SERVICE BULLETIN

ENGINE - LP TURBINE - PROVIDE AN OUTER DIFFUSER SUPPORT ASSEMBLY WITH SILVER PLATED CLINCH NUTS - CATEGORY CODE 6 - MOD.ENG-72-0110

V2500-ENG-72-0110

Modification of the LP Turbine Outer Diffuser Support Assembly
Fig.1

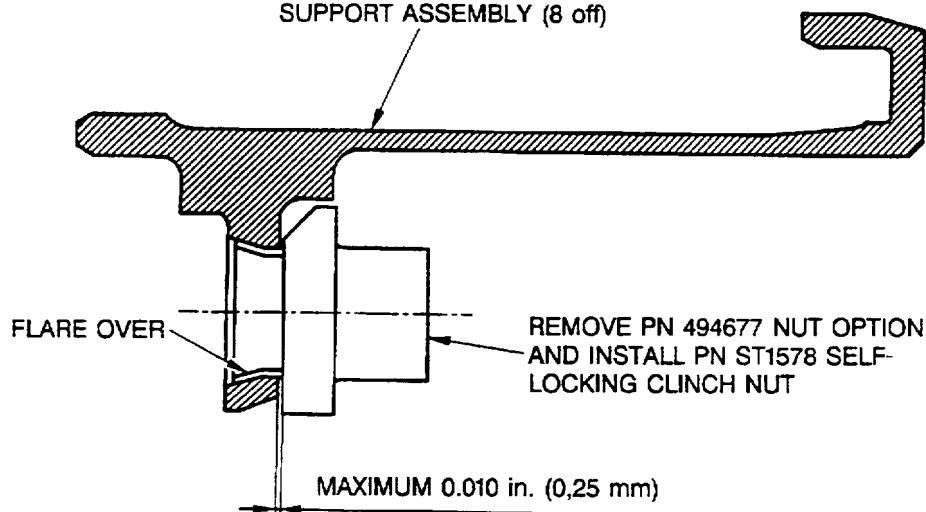
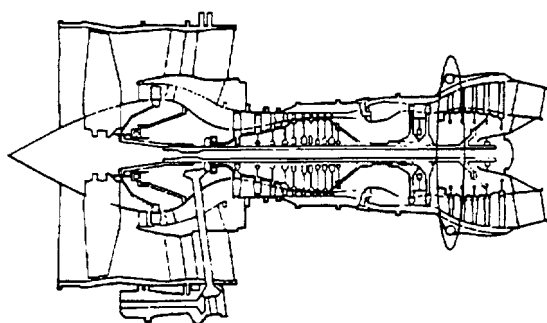
In the present configuration the Outer Diffuser Support Assemblies have fully silver plated Clinch Nuts. The silver plate can contribute to a chemical reaction which may result in sulfidation/corrosion of the support in hot gas environment.

- (1) The Self-Locking Clinch Nuts of the Outer Diffuser Support Assemblies are silver plated in the thread area only.
- (2) Existing Outer Diffuser Support Assemblies can be reworked, See Figure 1.
- (3) New Self-Locking Clinch Nuts will be available for replacement purposes.

Procedure	Supplementary Information	
(a) Machine off flared portion of clinch nut.	Refer to Figure 1. Make sure that the chamfer, bore and faces of the Support do not become damaged.

(d) Install P/N ST1578 (2 off) Self-Locking Clinch Nut onto the Support.	Refer to Figure 1. The nut shoulder must be located so that the Nut can not rotate.

(e) Flare over location diameter of Clinch Nut.	Use hydraulic portable yoke riveter. Axial movement up to 0.010in. (0.25 mm) is permitted. Refer to Figure 1.

(h) Re-number adjacent to existing Part Number. Use the vibration peening method.	Old Part Number	New Part Number
	3A0084	3A1907
	Refer to Reference (4), Task 70-09-00-400-501

REMOVE PN 3A0084 OUTER
DIFFUSER SUPPORT ASSEMBLY
(8 off), DO A MODIFICATION,
RE-NUMBER AND INSTALL
PN 3A1907 OUTER DIFFUSER
SUPPORT ASSEMBLY (8 off)
